UNITED STATES  
DEPARTMENT OF THE INTERIOR  
GEOLOGICAL SURVEYSUBMIT IN TRIE  
(Other instruction  
verse side)ATE\*  
a reForm approved.  
Budget Bureau No. 42-R1424.

Cities Service Federal

Bell Petroleum Company

(Other) Possibly rotary-Size of Casing X

# BASE ROTARY TABLE

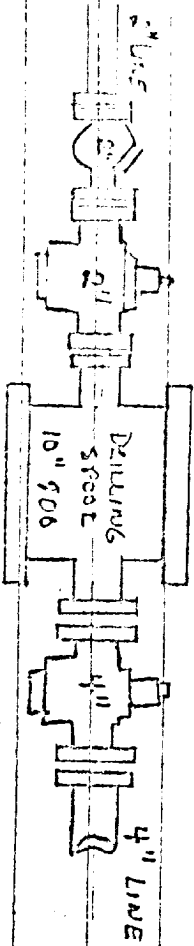
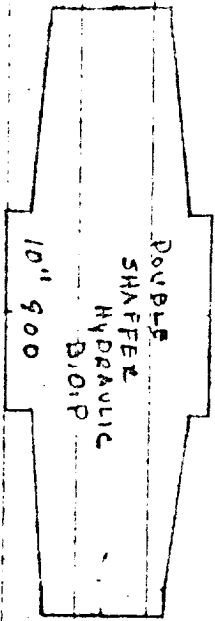
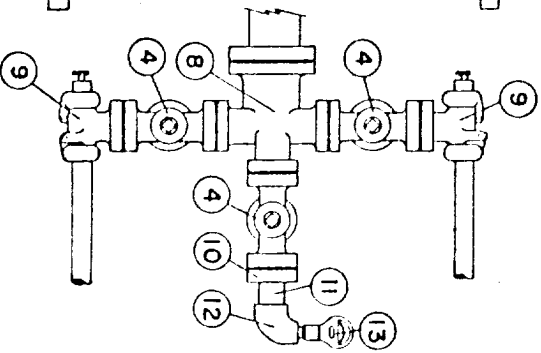
Flow Line Will Have To Be  
MADE TO FIT OVER  
Rotary
